Fiftieth session

**Work of the TDG Sub-Committee on matters of
interest to the GHS Sub-Committee**

**Revision of the Manual of Tests and Criteria:
Parts III, IV and V (Sections 30 to 51)**

**Transmitted by the Chairman of the Working Group on Explosives on
behalf of the Working Group**

FIGURE 31.1: OVERALL PROCEDURE FOR CLASSIFICATION OF FLAMMABLE AEROSOLS

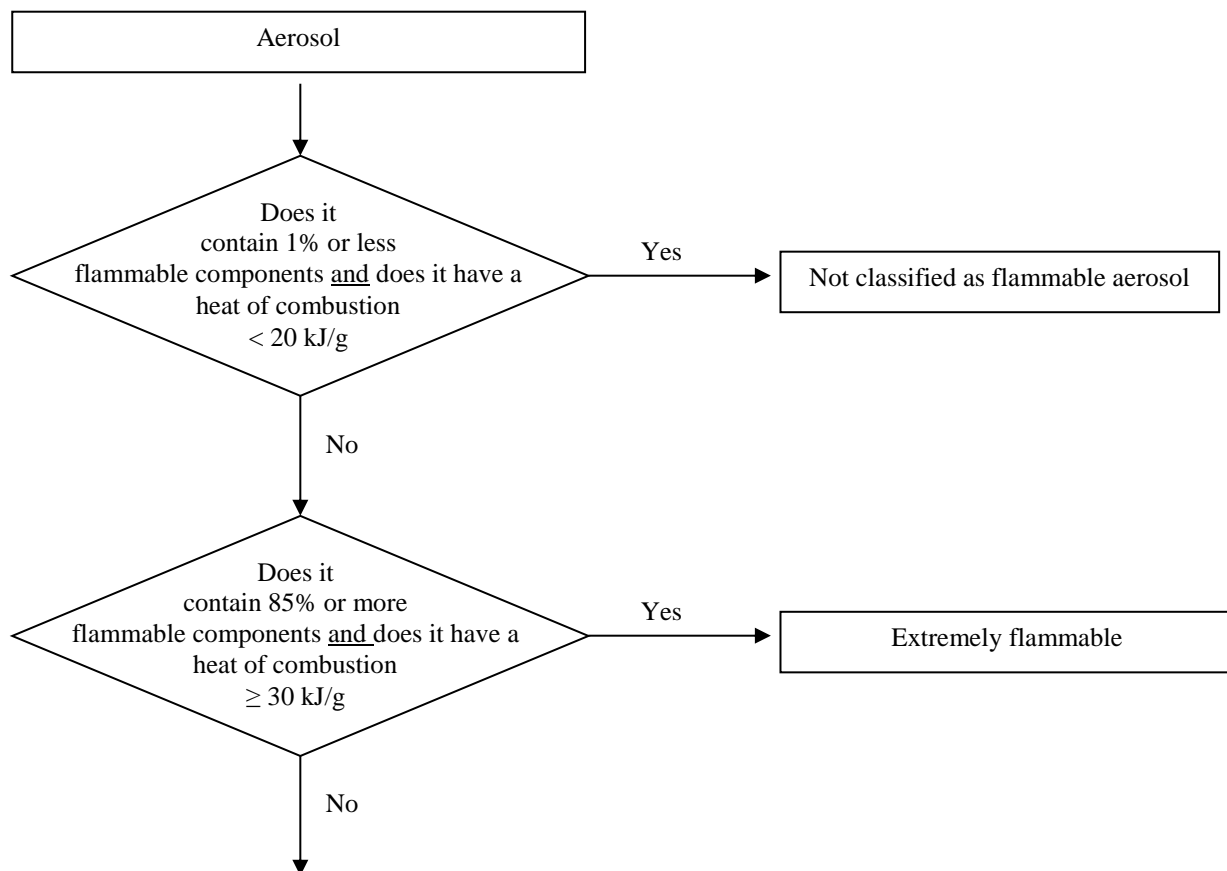
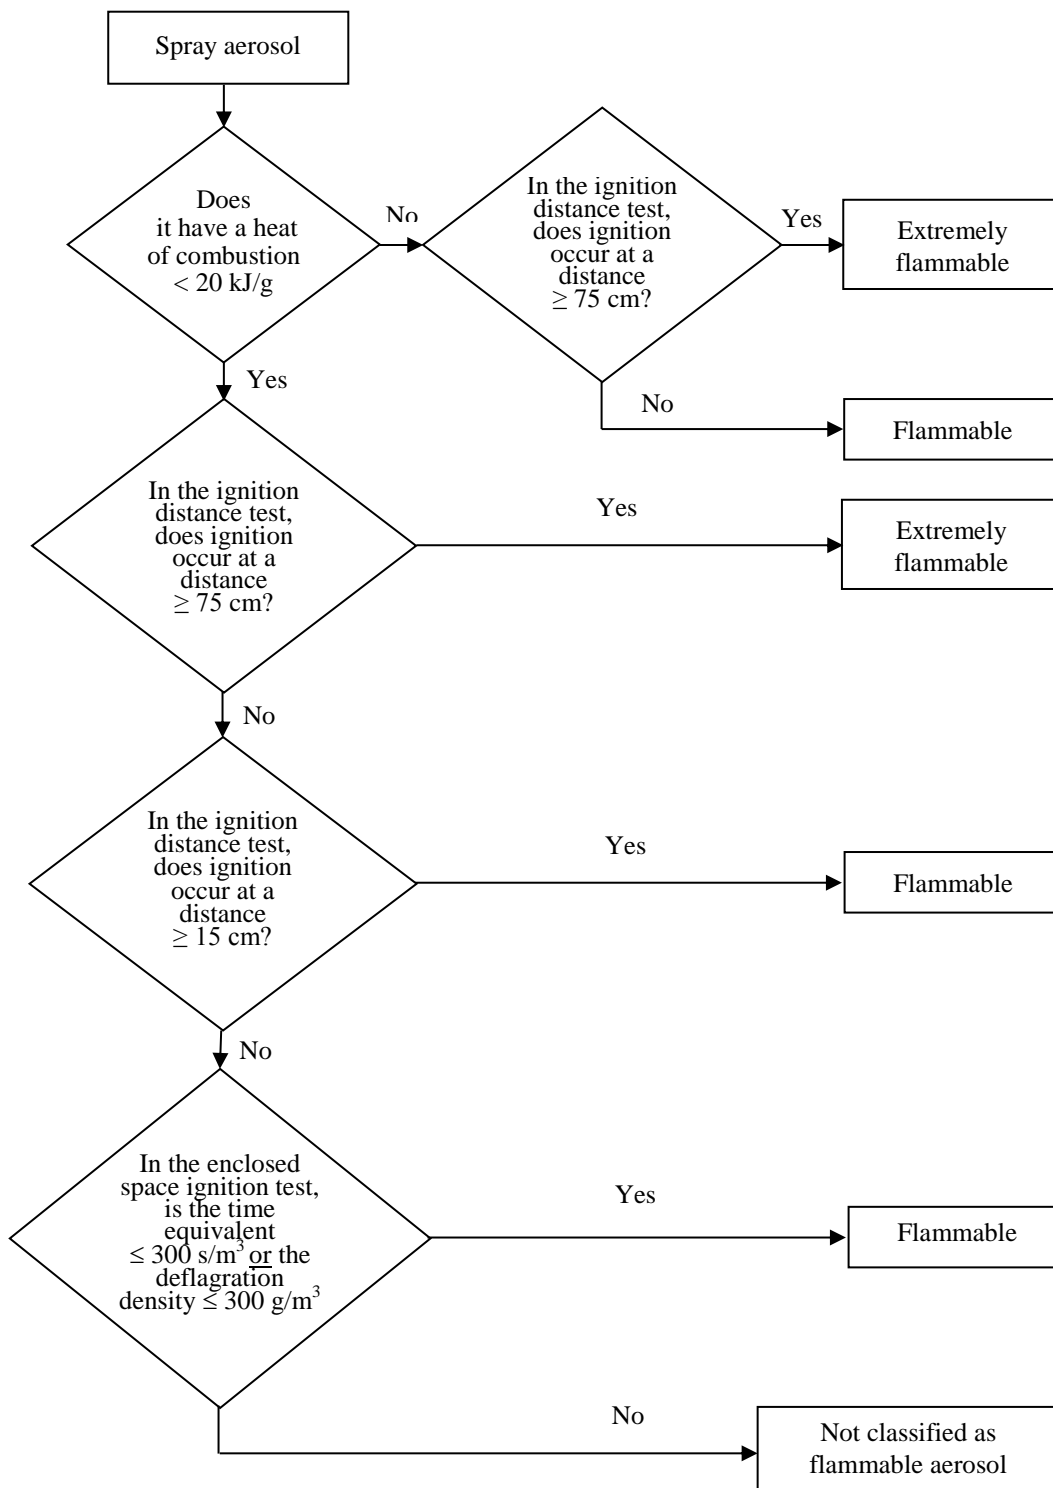
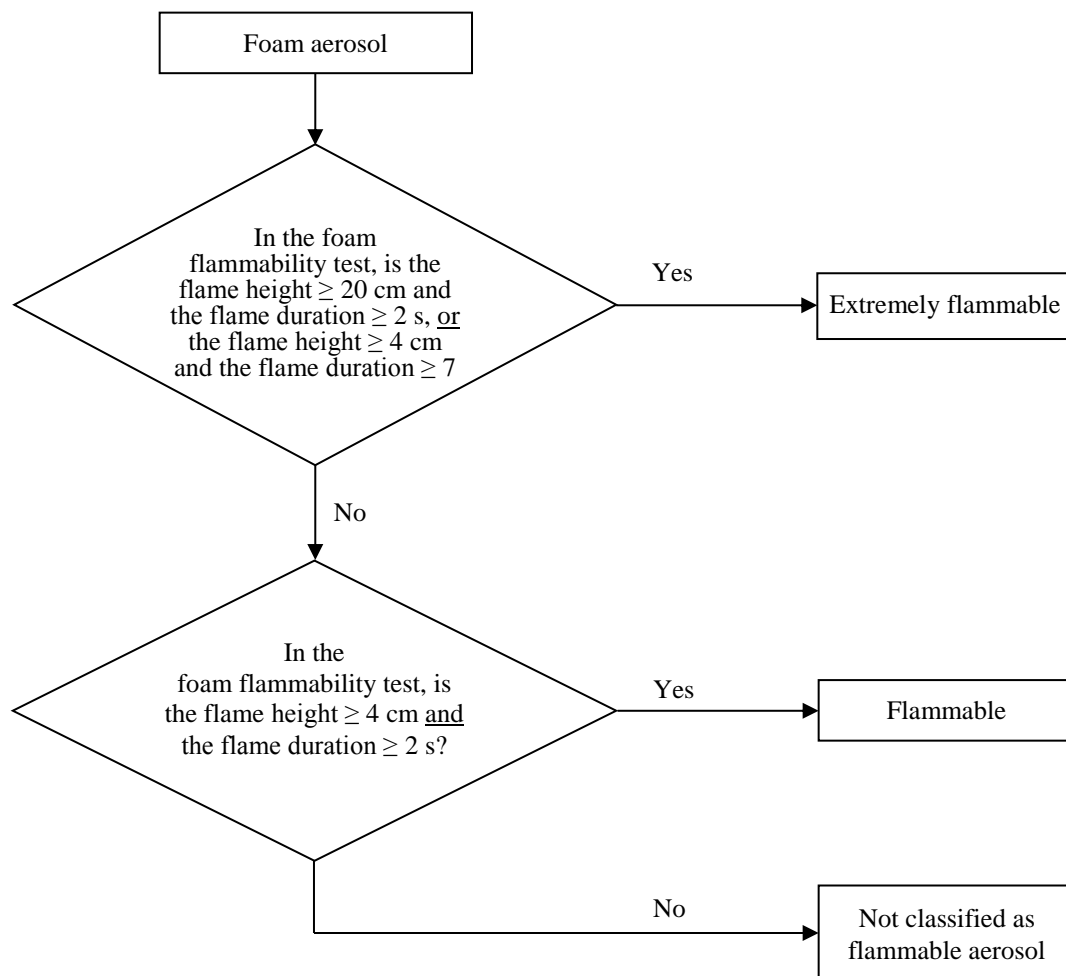
31.3.5 The classification ~~criteria procedure~~ for aerosols, spray aerosols and foam aerosols is summarized in figures 31.1, 31.2 and 31.3 respectively.

Figure 33.2.1.3 : FLOW CHART FOR CLASSIFICATION OF ASSIGNING READILY COMBUSTIBLE/FLAMMABLE SOLIDS, EXCEPT METAL POWDERS, TO DIVISION 4.1

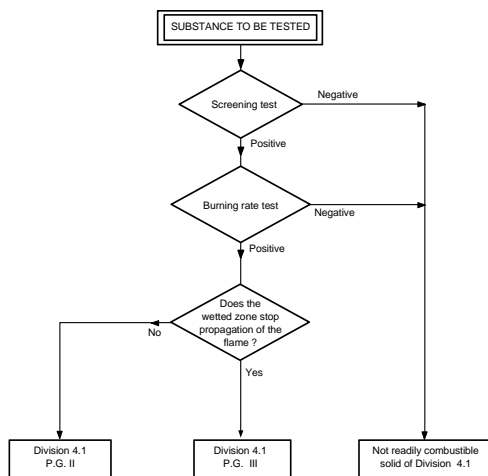
33.2.1.1.1 Section 33.2.1.3 presents the United Nations-scheme for the classification of readily combustible/flammable solids ~~of Division 4.1~~ (see Chapter 2.4, sub-section 2.4.2.2 of the Model Regulations and Chapter 2.7 of the GHS). The text should be used in conjunction with the classification principles given in Chapter 2.4, paragraphs 2.4.2.2.2 and 2.4.2.2.3 of the Model Regulations, Chapter 2.7, paragraph 2.7.2 of the GHS, the flow chart given in Figure 33.2.1.3 and the test prescription given here in 33.2.1.4.

Figure 33.3.1.3.3.1: CLASSIFICATION OF SELF-HEATING SUBSTANCES

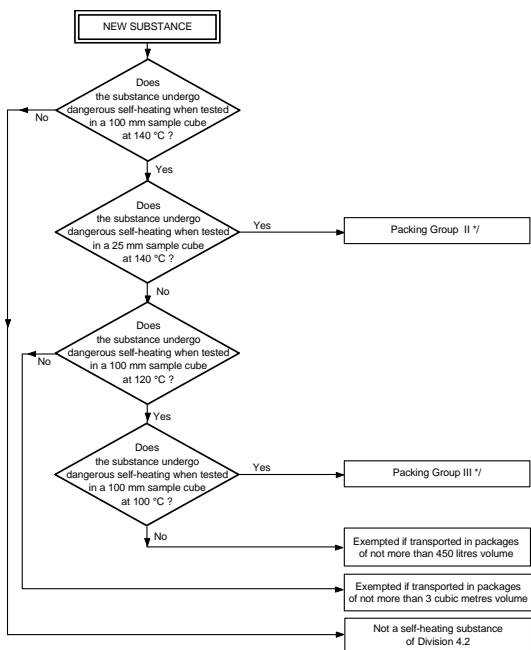
Replace “Packing group II” with “Packing group II / Category 1” and “Packing group III” with “Packing group III / Category 2” and “...if transported...” with “...if contained...”(two times); delete “of Division 4.2”

Figure 38.3.4.2: Relation between the Peak Acceleration and the Mass for large batteries (equal or above 12.0 kg).

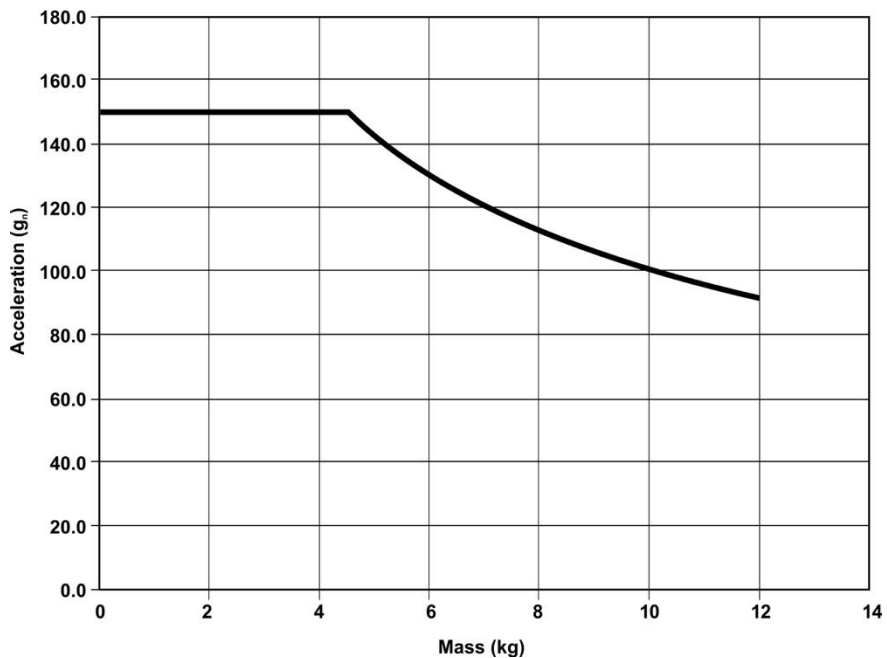
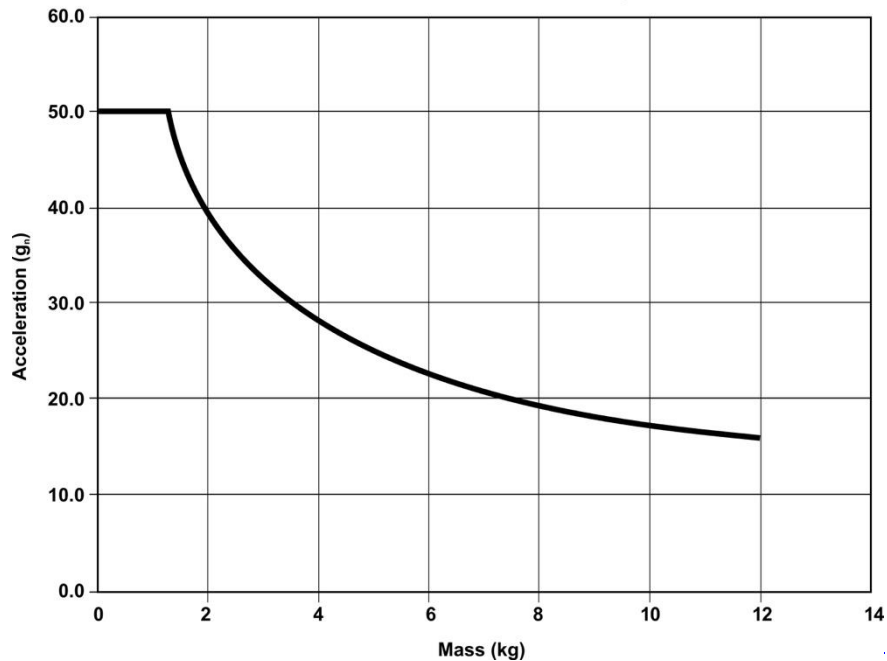
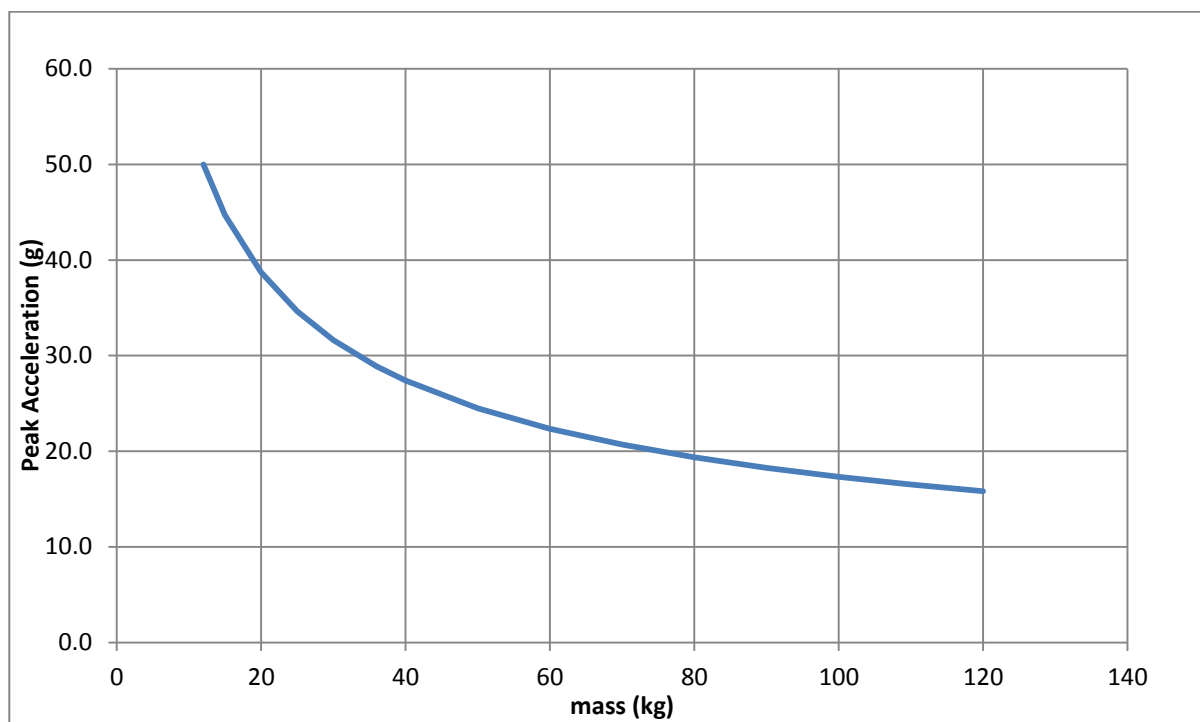
Note by the secretariat: Correction to the 6th revised edition, refer to [ST/SG/AC.10/11/Rev.6/Corr.1](#).
